Work Order ID 146353

Item Name: AS350/AS355 Heli-Utility-Basket™ Long Version - Fits LH or RH

DART SERVICE INSTRUCTION

TO AMEND INSTALLATION INSTRUCTIONS D350-607-1 REV. A AND
INSTRUCTIONS FOR CONTINUED AIRWORTHINESS ICA-D350-607 REV. 6

**FIGURE 1: CHANGES TO FIGURE 2 OF D350-607-1 REV. A
AND FIGURE 25-1 OF ICA-D350-607 REV. 6**

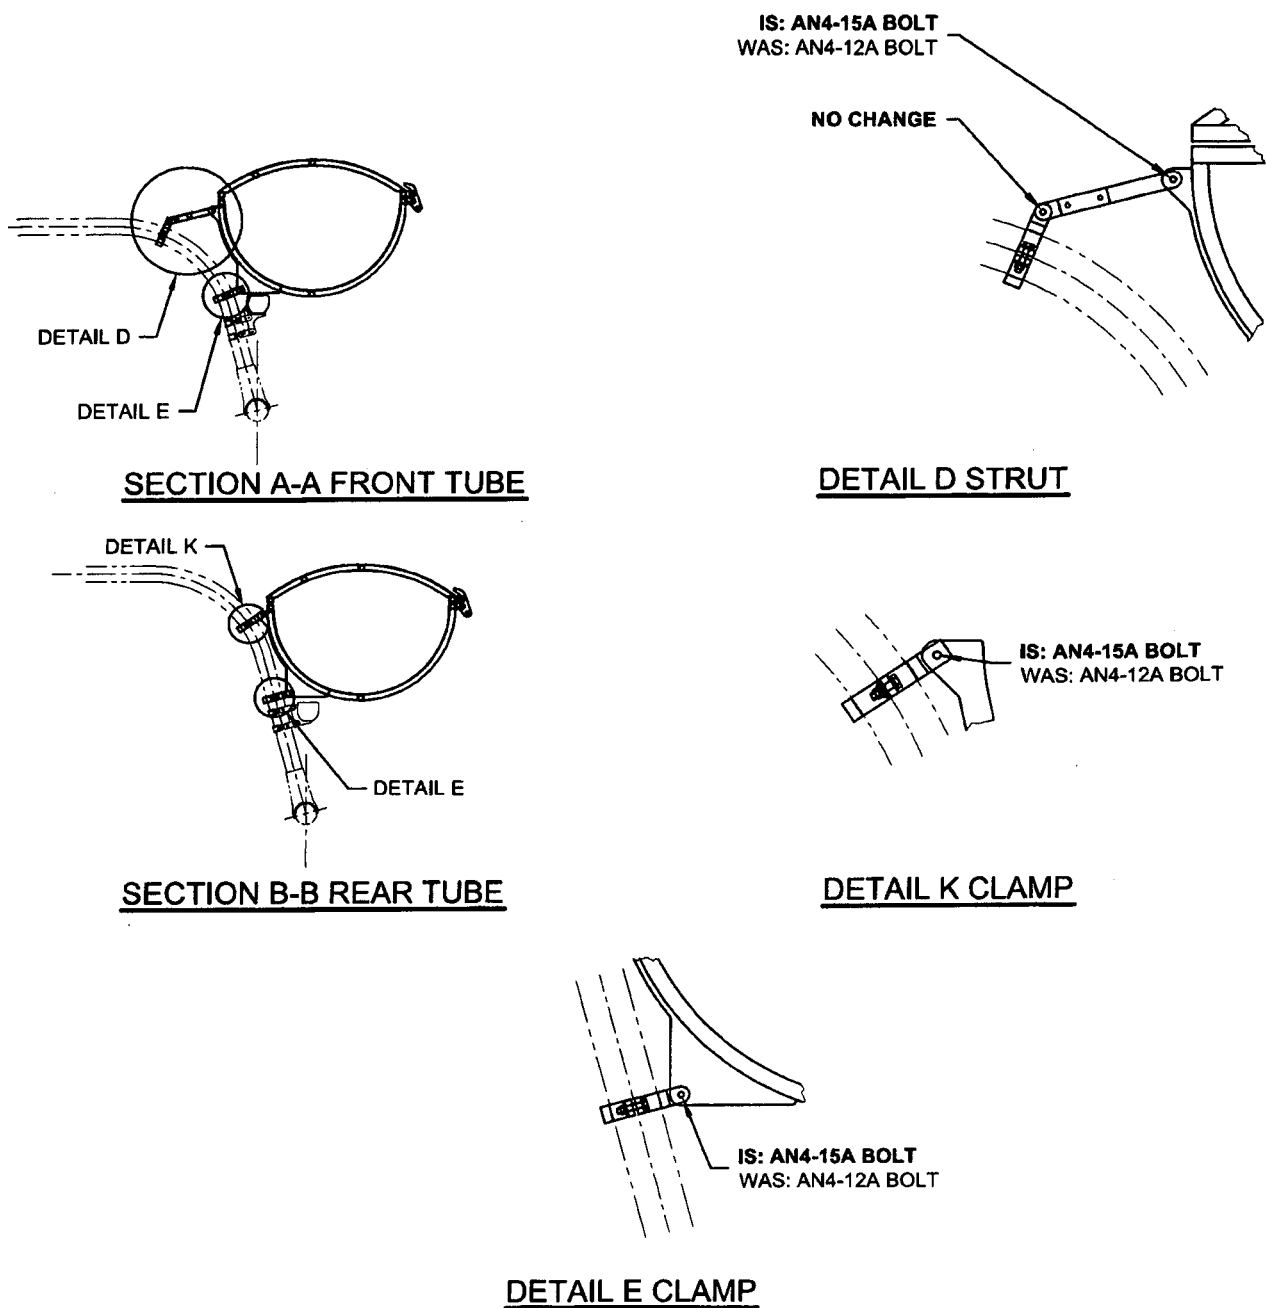
- 2.1 Sheet 2 of this DSI amends Figures 2 of D350-607-1 Rev. A and 25-1 of ICA-D350-607 Rev. 6;
- 2.2 Sheet 3 of this DSI amends Figures 3 of D350-607-1 Rev. A and 25-2 of ICA-D350-607 Rev. 6;
- 2.3 Sheet 4 of this DSI amends the Parts Lists of Installation Instructions D350-607-1 Rev. A (Sections 6.1 and 6.2) and ICA-D350-607 Rev. 6 (Sections 25.27.1 and 25.27.2).

**FIGURE 2: CHANGES TO FIGURE 3 OF D350-607-1 REV. A
AND FIGURE 25-2 OF ICA-D350-607 REV. 6**

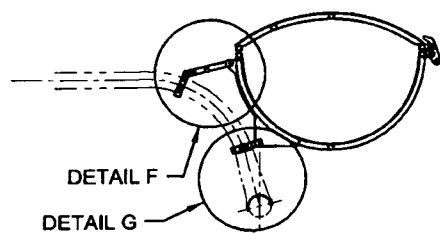
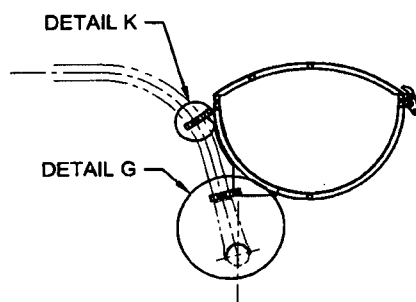
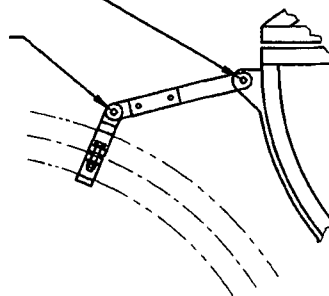
IS: AN4-15A BOLT
WAS: AN4-12A BOLT

IS: AN4-15A BOLT
WAS: AN4-12A BOLT

IS: AN4-15A BOLT
WAS: AN4-12A BOLT
